Subject: **Revised application for Section 404 Nationwide Permits (NWP) 23, 33 & 12, and Section 401 Water Quality Certification** for the replacement of Bridges No. 116 & 117 over Hog Swamp on SR 2262 (Bethesda Church Road) in Robeson; TIP Project B-4619; Federal Aid Project No. BRZ-2262 (1).

Please find enclosed revised PCN pages, permit drawings and utility drawings for the above referenced project and replace those from our original application dated October 17, 2012. The revised drawings reflect minimization measures resulting from coordination that has taken place since then. In particular, these drawings depict the use of a temporary work bridge instead of a temporary work pad for constructing Bridge No. 116 and shifting utility relocations to the north side of the project.

Permit Drawing  
Sheet 2 of 13  
Revised 11-27-12

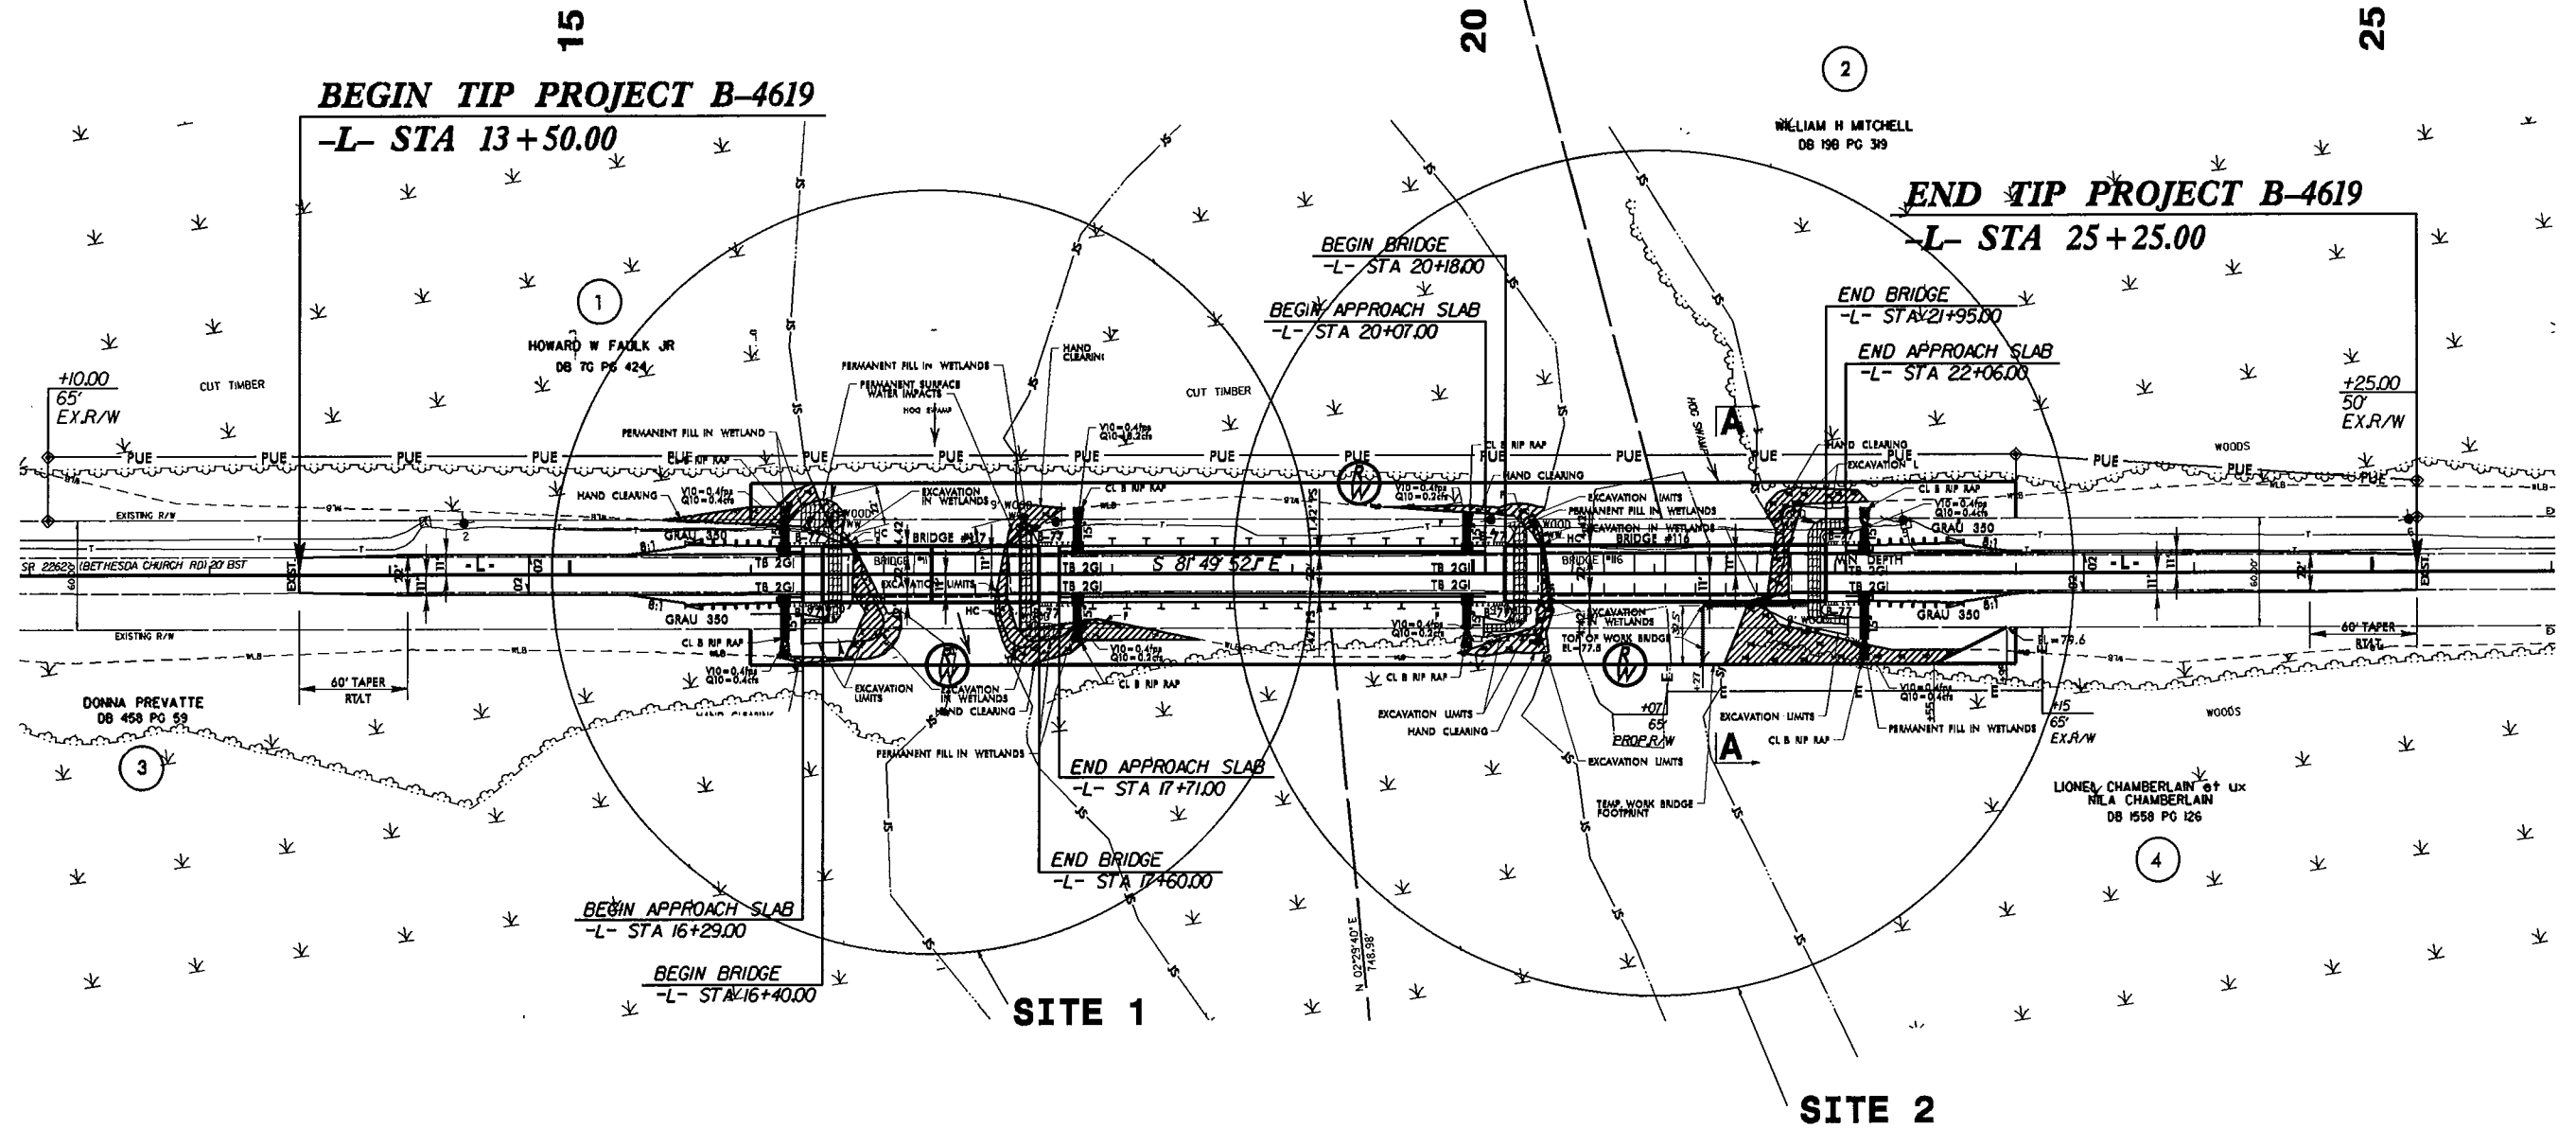
REVISIONS  
11-16-12 RIGHT OF WAY REVISION: 390 FEET OF PERMANENT UTILITY EASEMENT HAS BEEN ADDED ON PARCEL NUMBER 1 AND 225 FEET OF PERMANENT UTILITY EASEMENT HAS BEEN ADDED ON PARCEL NUMBER 2. RCB

Permit Drawing  
Sheet 3 of 13  
Revised 11-27-12

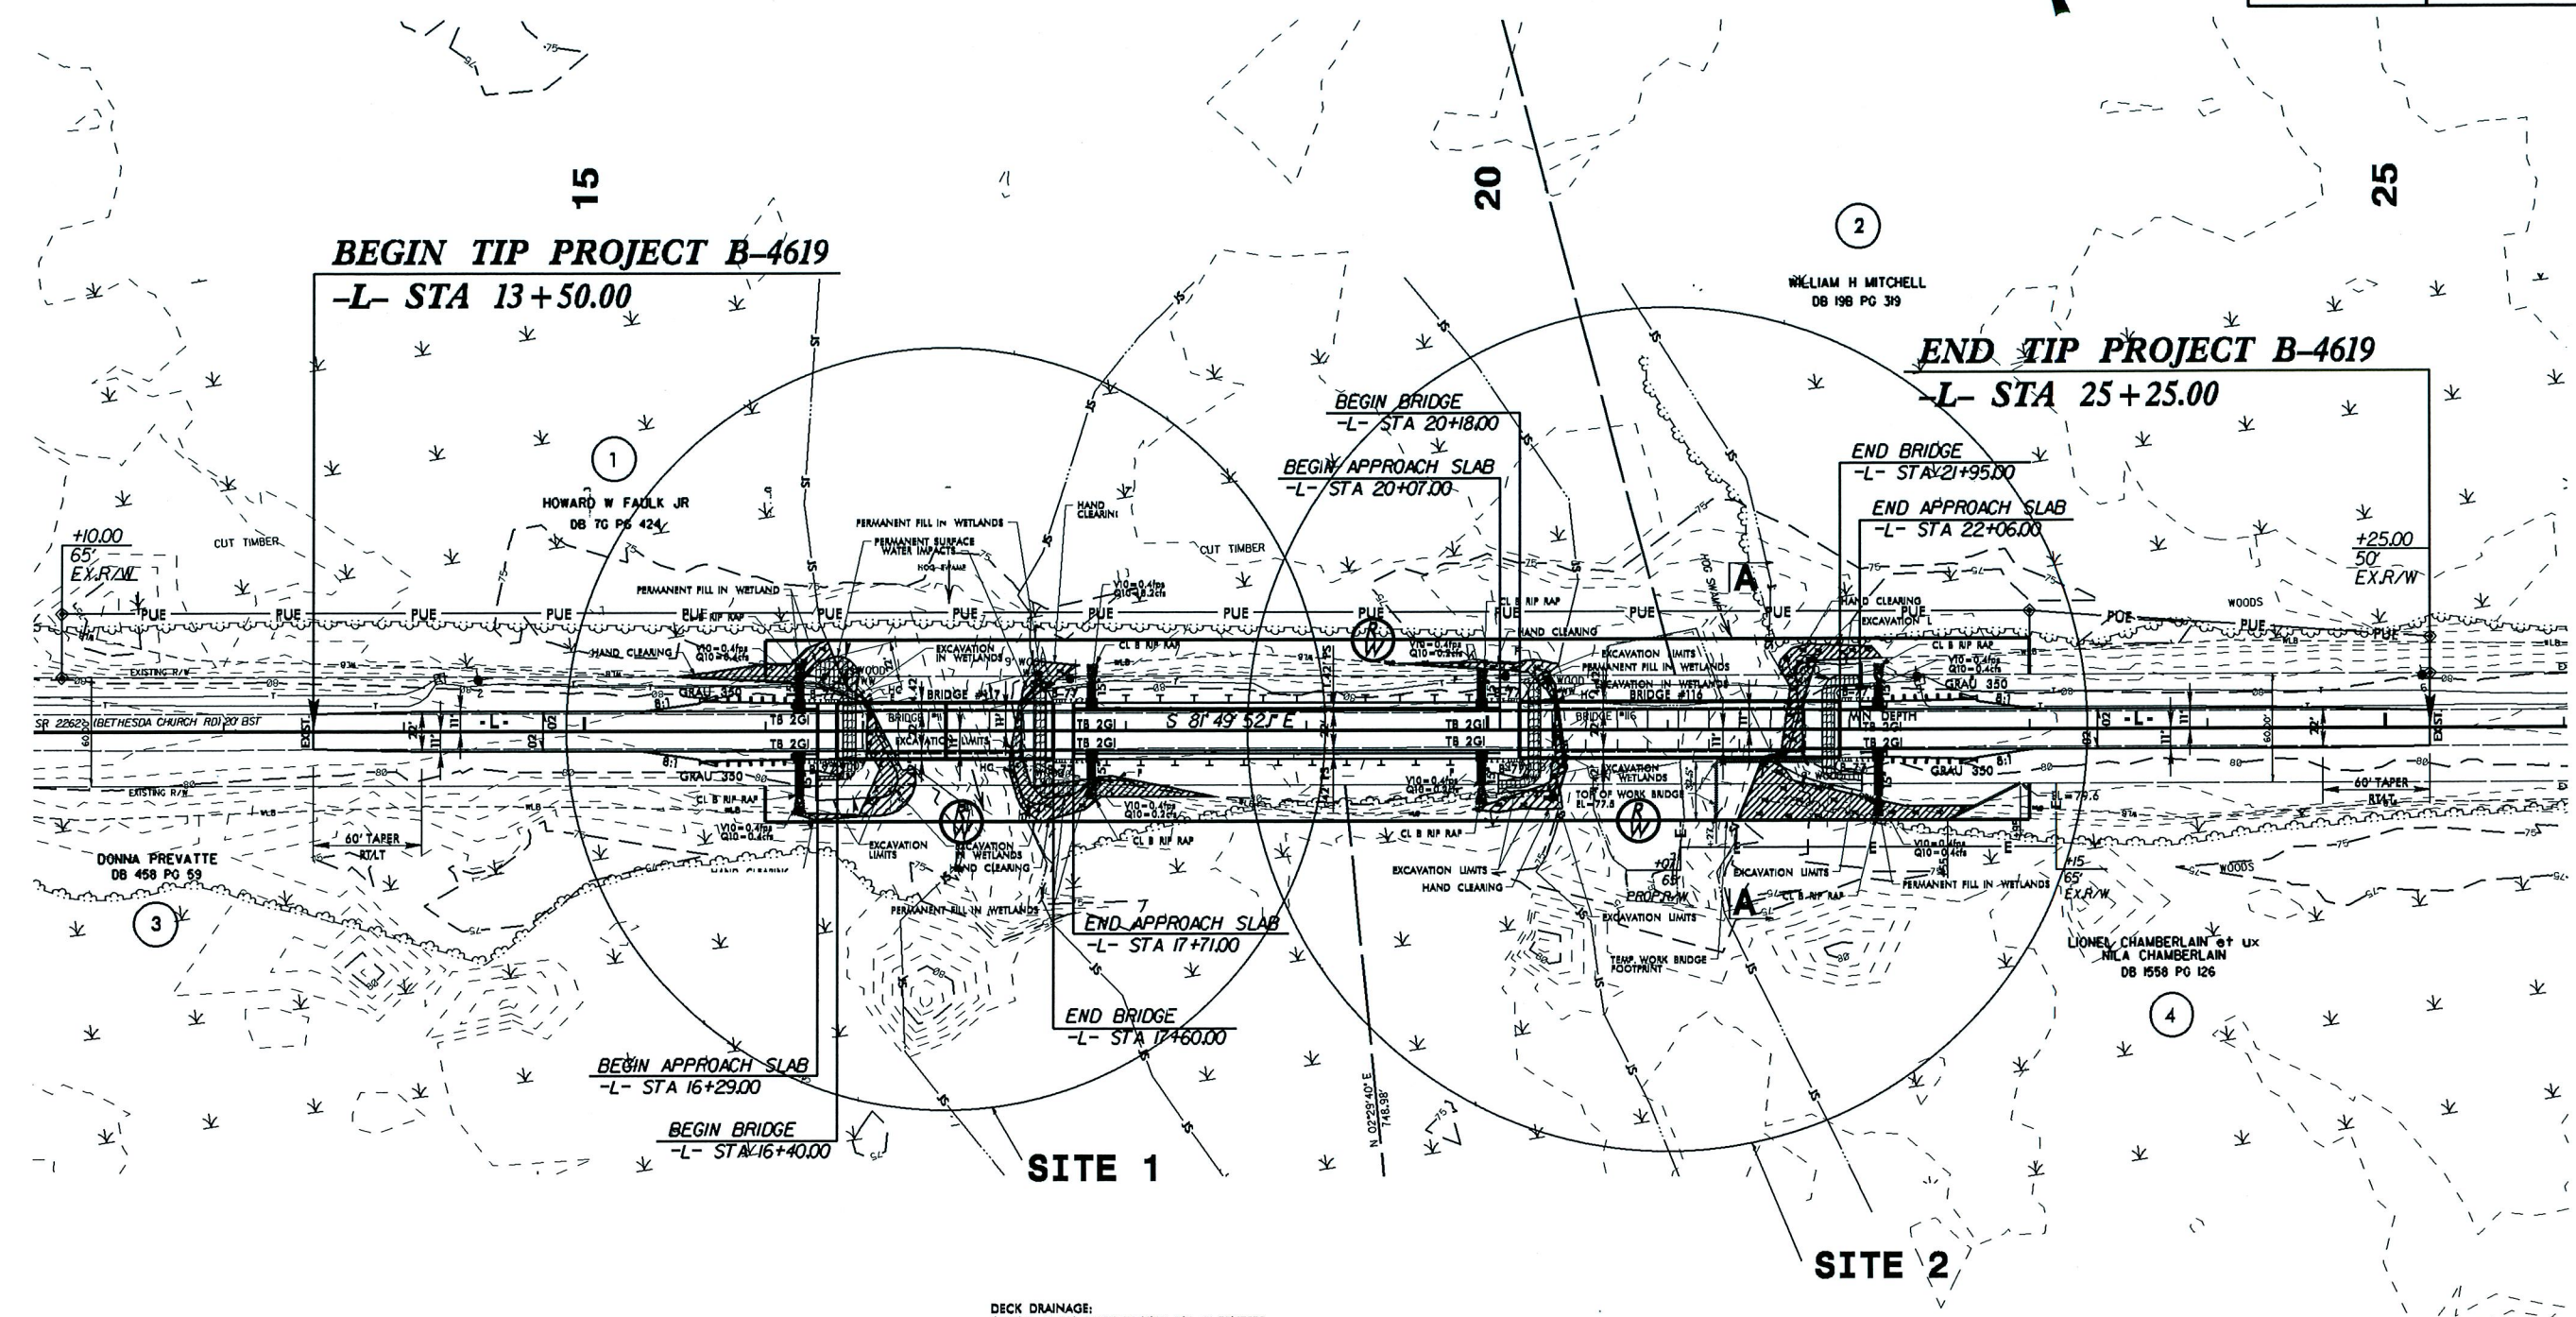
11-16-12 RIGHT OF WAY REVISION: 350 FEET OF PERMANENT UTILITY EASEMENT HAS BEEN ADDED ON PARCEL NUMBER 1, AND 225 FEET OF PERMANENT UTILITY EASEMENT HAS BEEN ADDED ON PARCEL NUMBER 2. RCB
